Technical Assessment

APPLICATION DETAILS			
OFFICER NAME	Corey Cullen	APPLICATION NO.	PA24/747
PROPOSAL	Place of Worship		
LOCATION	24 Nettleton Road & 30 Nettleton Road		
APPLICATION RECEIVED	26/11/24	APPLICATION DATED	18/11/24
ZONING	Urban Development	LOT AREA	5048m ²

Light Industrial designation within the Byford District Structure Plan

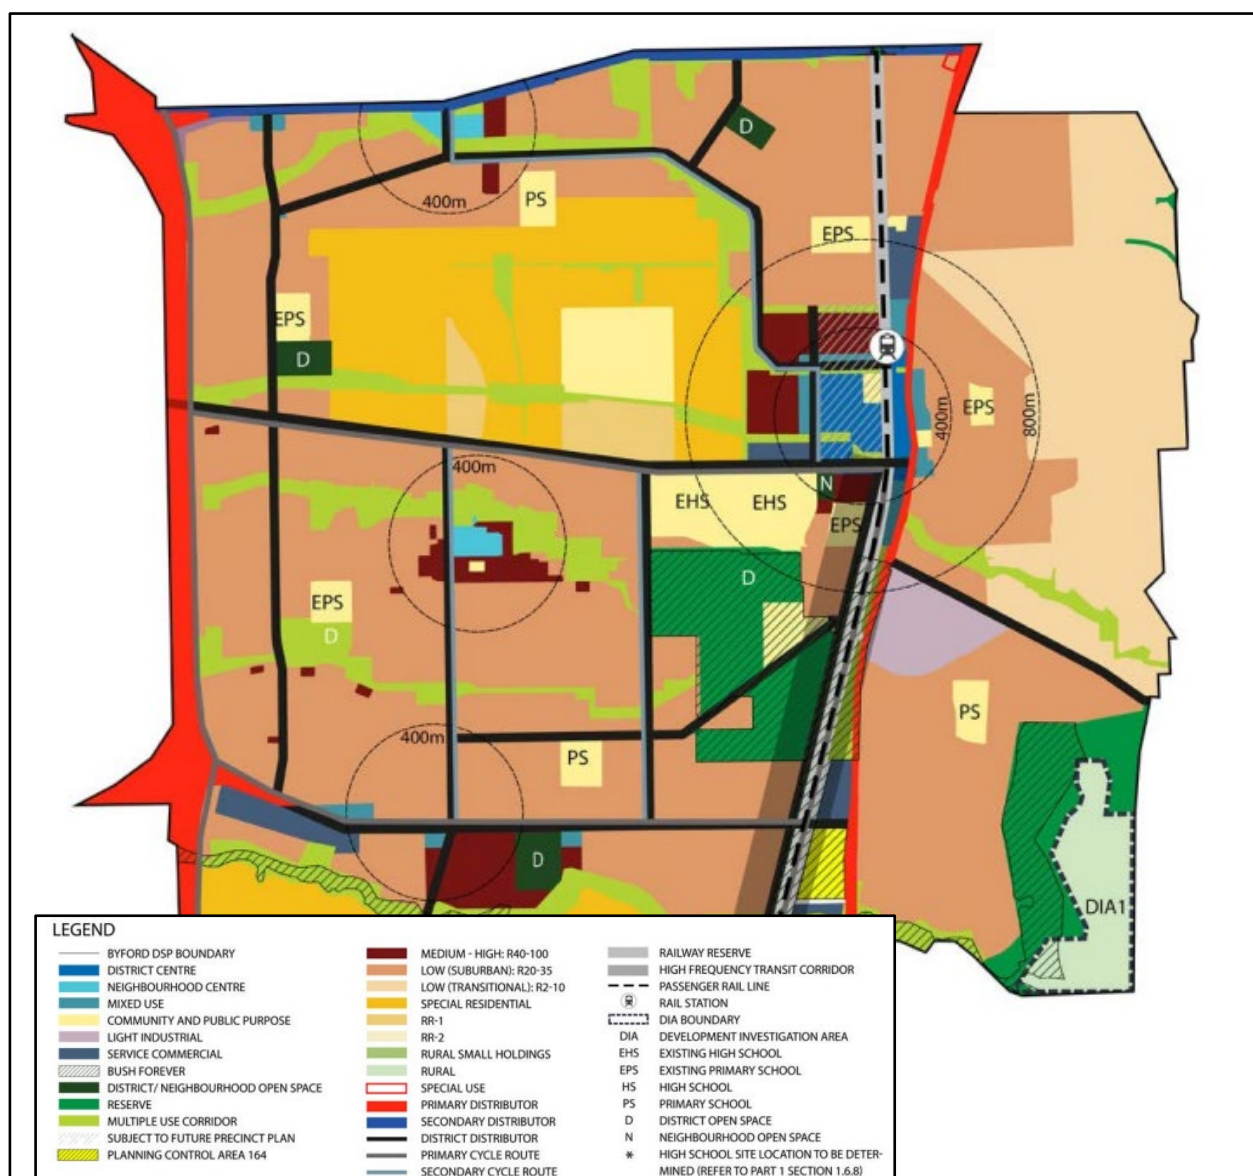
The subject site is located within the Byford District Structure Plan where it is designated as Light Industrial area. Scheme Amendment No. 5 seeks to normalise the zoning in accordance with the Byford DSP. It is noted that a 'Place of Worship' is also an 'A' use under Light Industry zoning, indicating the approval would not be non-conforming use or incapable of approval once the Scheme amendment is effective.
